RE: Recommendation to approve NB Kenney Change Order 005

NB Kenney is submitting original copies of Change Order 005 for the Brookline High School Deferred Maintenance Project for acceptance by the Town of Brookline (ToB). Hill and WRA have previously reviewed, negotiated where applicable, and agree that all items listed in this Change Order are fair, reasonable for the described scope of work, and are compensable adjustments to the Lump Sum Contract. This change order is an additional cost funded from Owner' Hard Cost Contingency total **\$40,310.00**.

## Change Order

**PROJECT: (name and address)**Brookline High School  
115 Greenough Street  
Brookline, MA 02445**OWNER: (name and address)**Town of Brookline - Represented by  
The Brookline Building Commission  
333 Washington Street  
Brookline, MA**CONTRACT INFORMATION:**Contract For: Deferred Maintenance  
Expansion Project**ARCHITECT: (name and address)**William Rawn Associates, Architects, Inc.  
10 Post Office Square  
Boston, MA 02109**CHANGE ORDER INFORMATION:**Change Order #: 5  
Date: November 29, 2021**CONTRACTOR: (name and address)**N.B. Kenney Company, Inc.  
68 Barnum Road  
Devens, MA 01434

**AWHP-Sub-03**

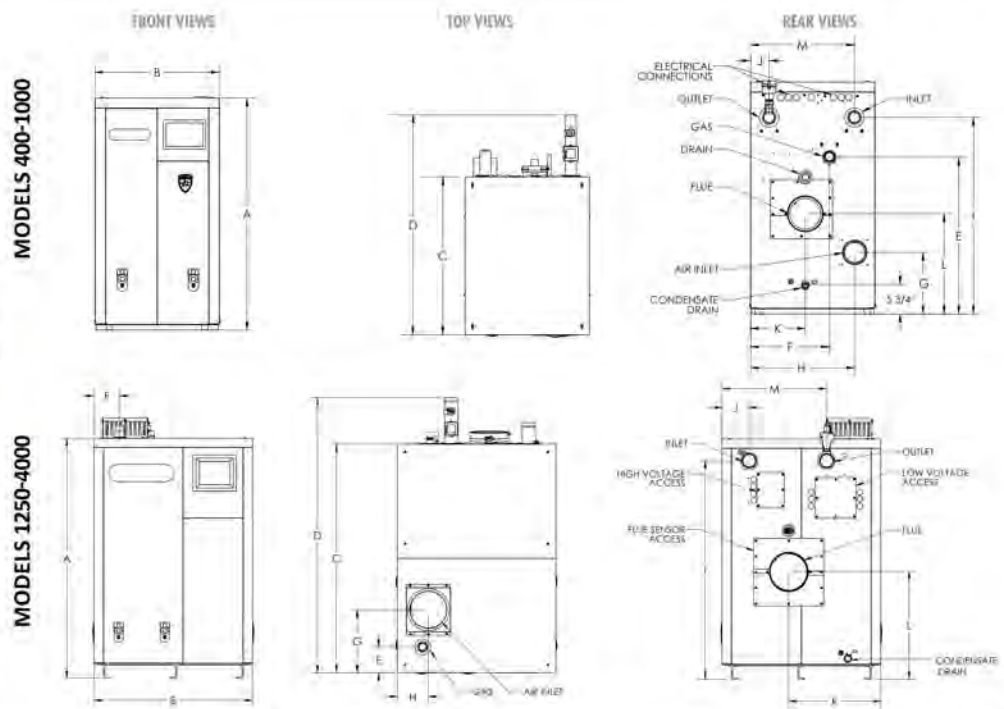
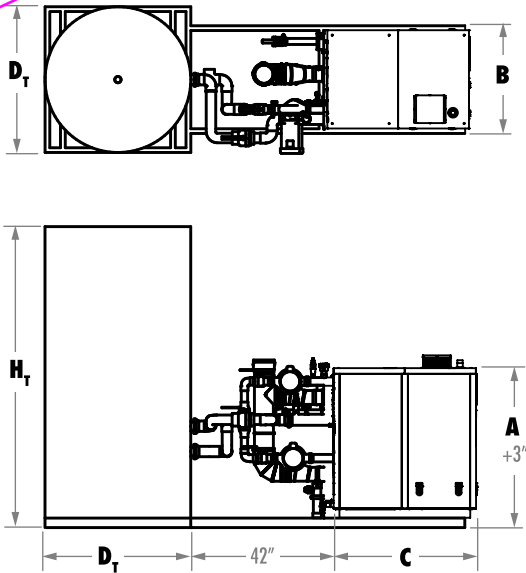
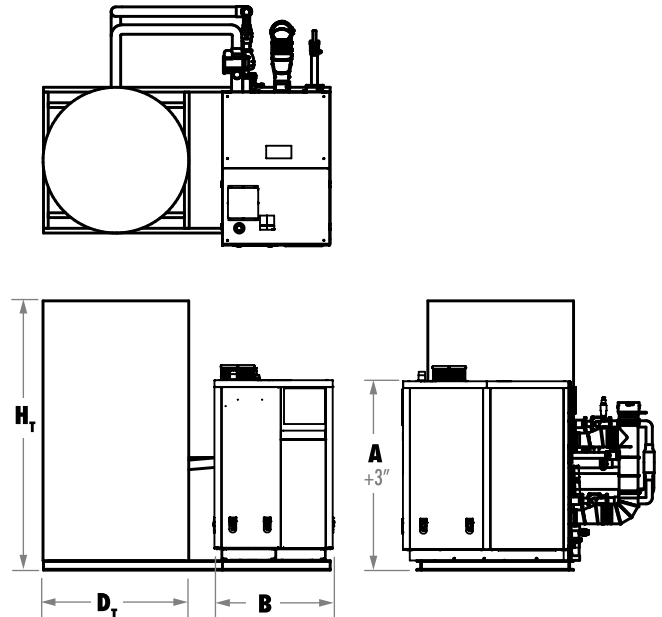
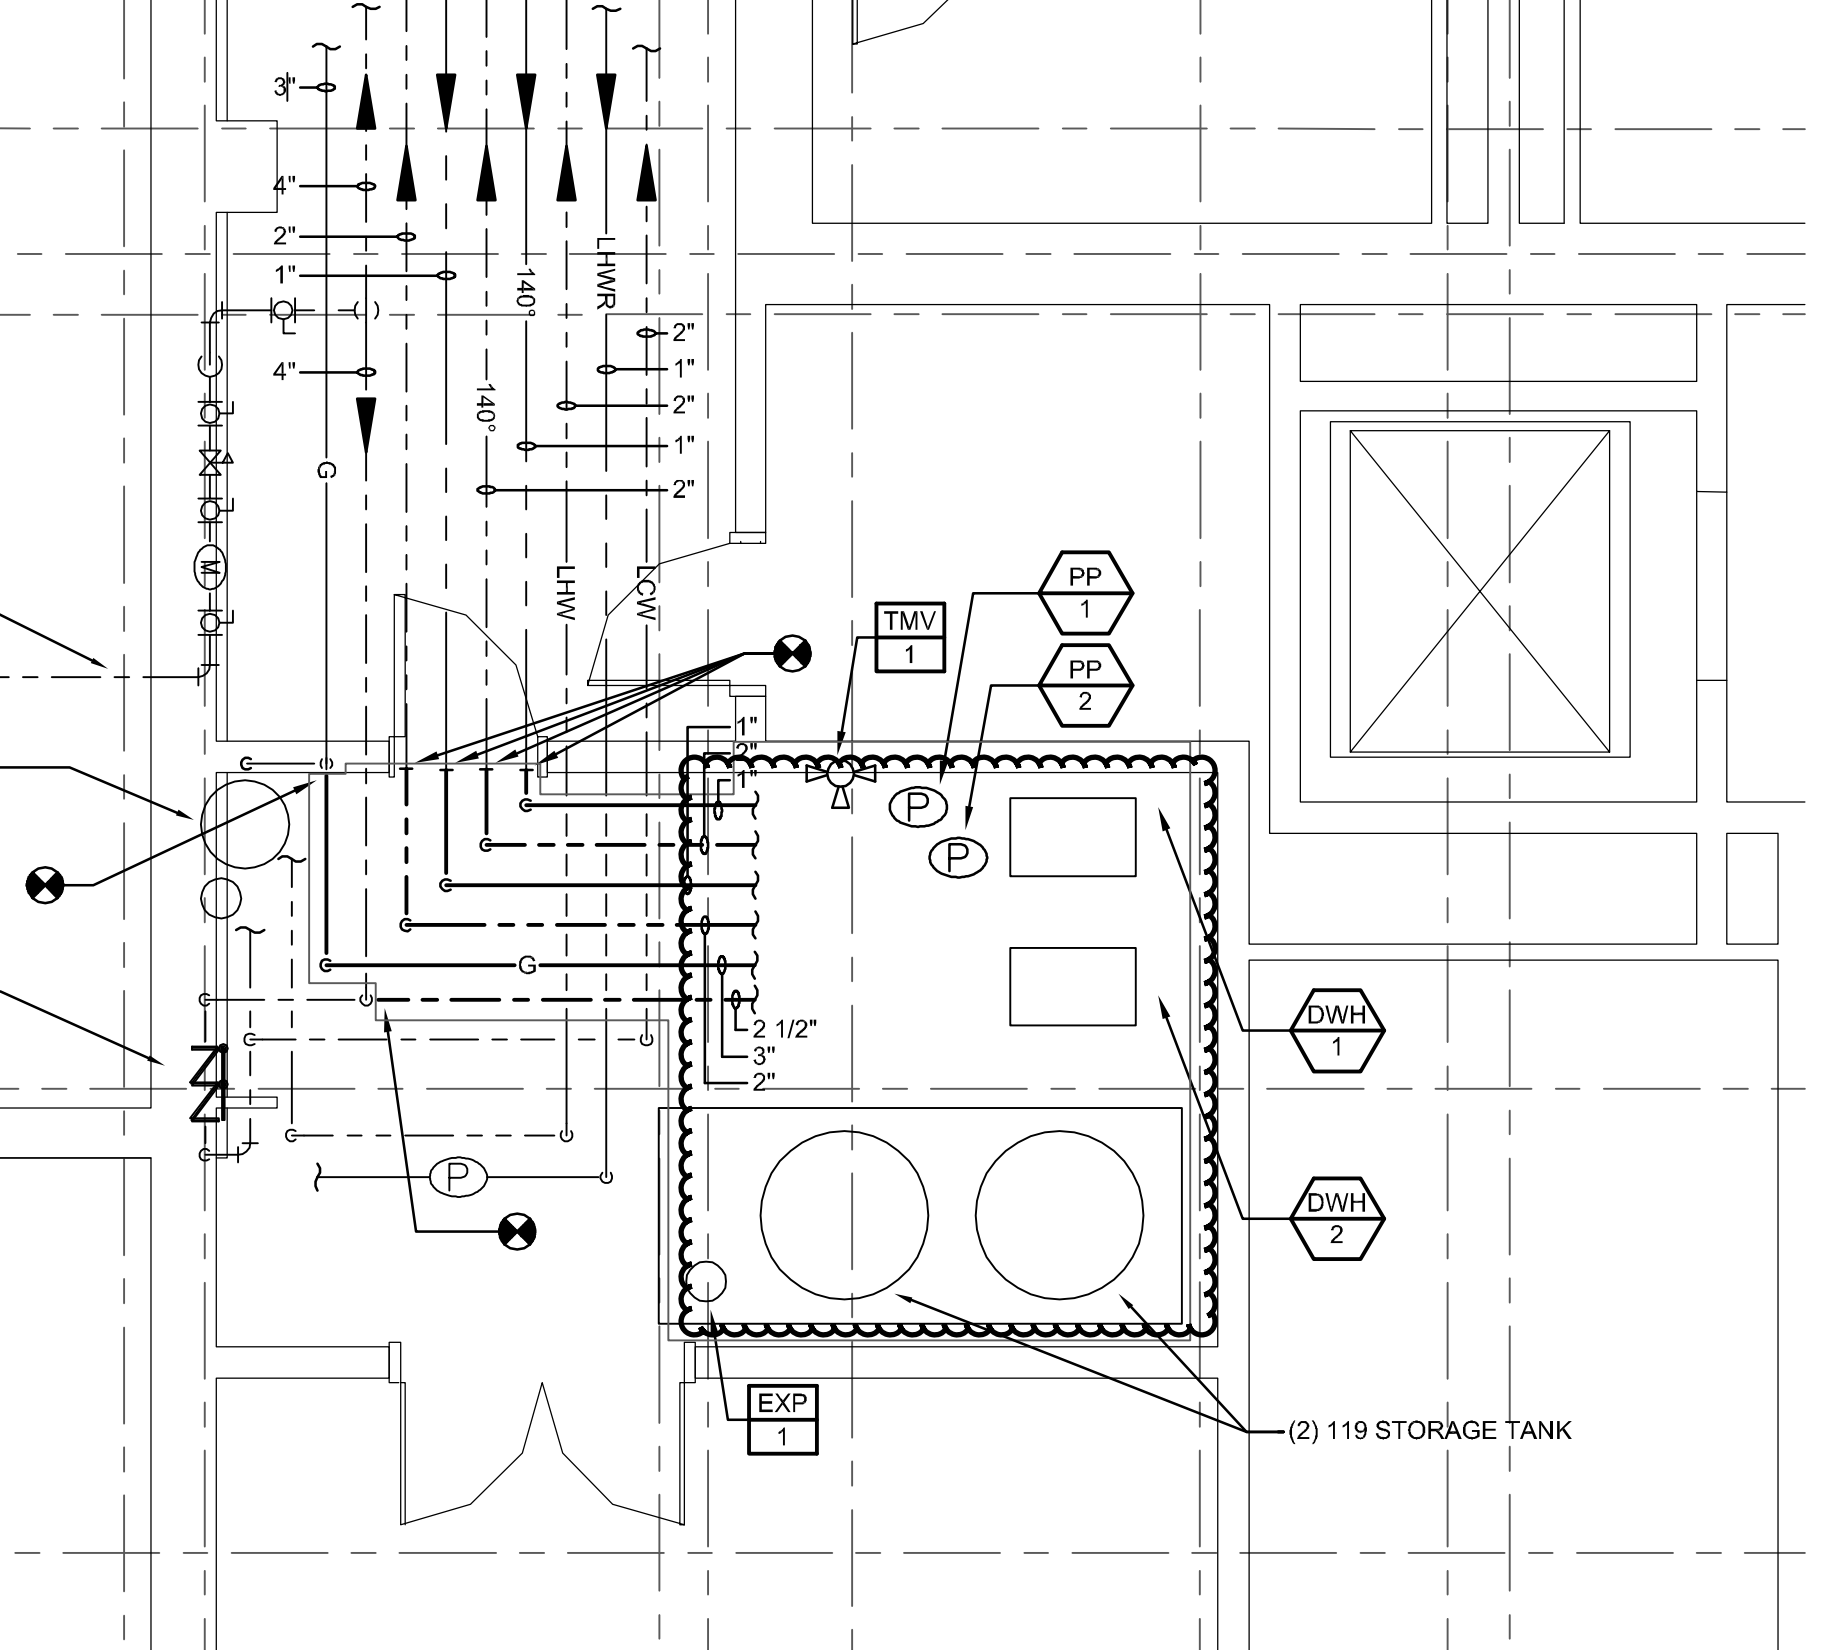
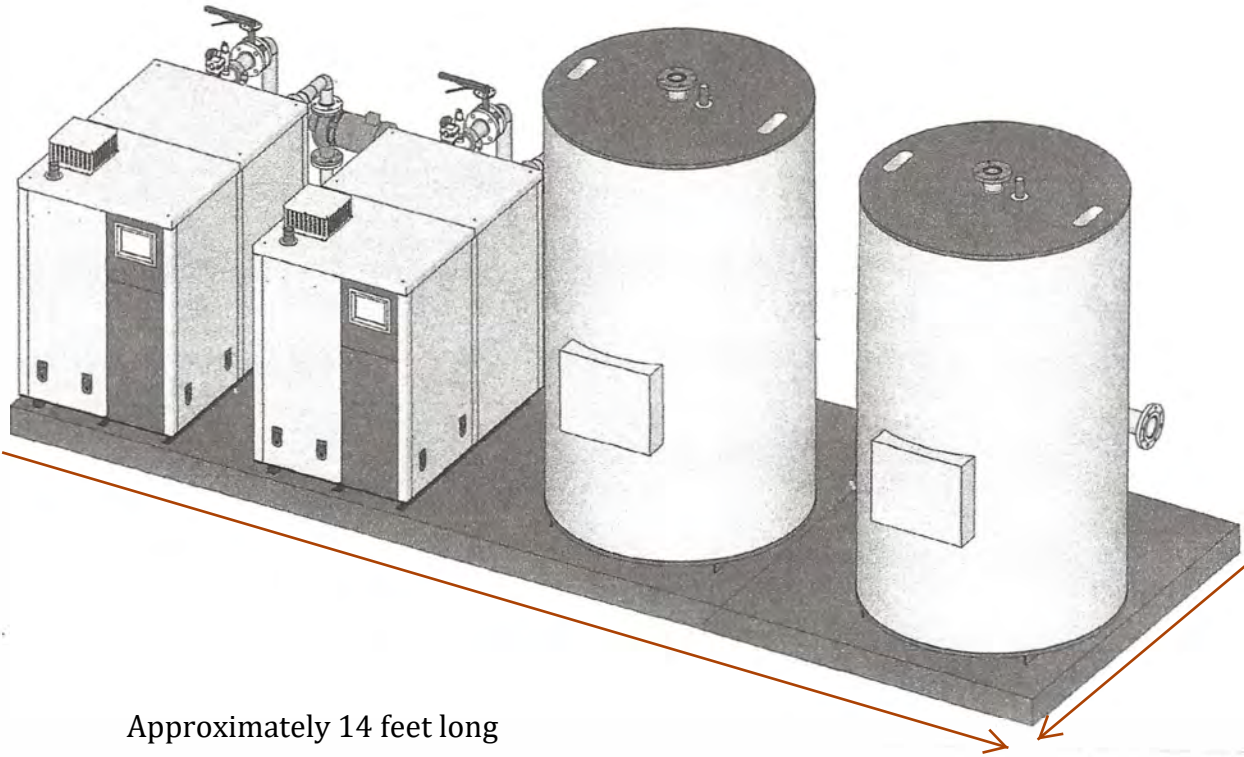
*We are hereby submitting the following questions for your response. These issues have potential time and cost impacts.* Reference is made to the attached 6 pages, one is a crop of P1-01-F, one is a sketch of the domestic water heater & storage tank skid along with 4 pictures for a total of 7 pages. This equipment is all mounted on a skid as shown, the skid is approximately 14' long and 7' wide. There is no way to get this unit into the basement where it replaces the existing system.

A review of the "crop" section of P1-01-F shows a layout that entirely different than the skid, Upon checking with Lochinvar this equipment is not available as independent components. NBK has no provisions to disassemble and reassemble this skid, in fact the skid will not fit in the designated area and a revised layout will need to be determined with installation.

By specification and submittal, the DWH and Tank is a Lochnivar Packaged Solution. The manufacturer submittal refers to this assembly as a package system on submittal pages 5, 6 and 7. On page 7 of the submittal, the notes state that packaged solutions with multiple units (there are 2 boilers and 2 tanks) are designed as breakaway systems and breakaway systems are factory disassembled for shipping and require field assembly. NBK should verify with manufacturer why the packaged solution was delivered as one assembly.

RFS agrees the package needs to be disassembled and reassembled in place. The submittal does not provide specific dimensions for the entire skid – only the individual pieces. Submittal 224500-2.1 indicates the size of a 119 gallon tank as 62 1/2" tall by 28" diameter. It appears all individual units will fit in the elevator and through the doors. NBK should verify all dimensions and the path through the building to the final location. GC is responsible for coordinating unit sizes with installation and clearance requirements within the building.
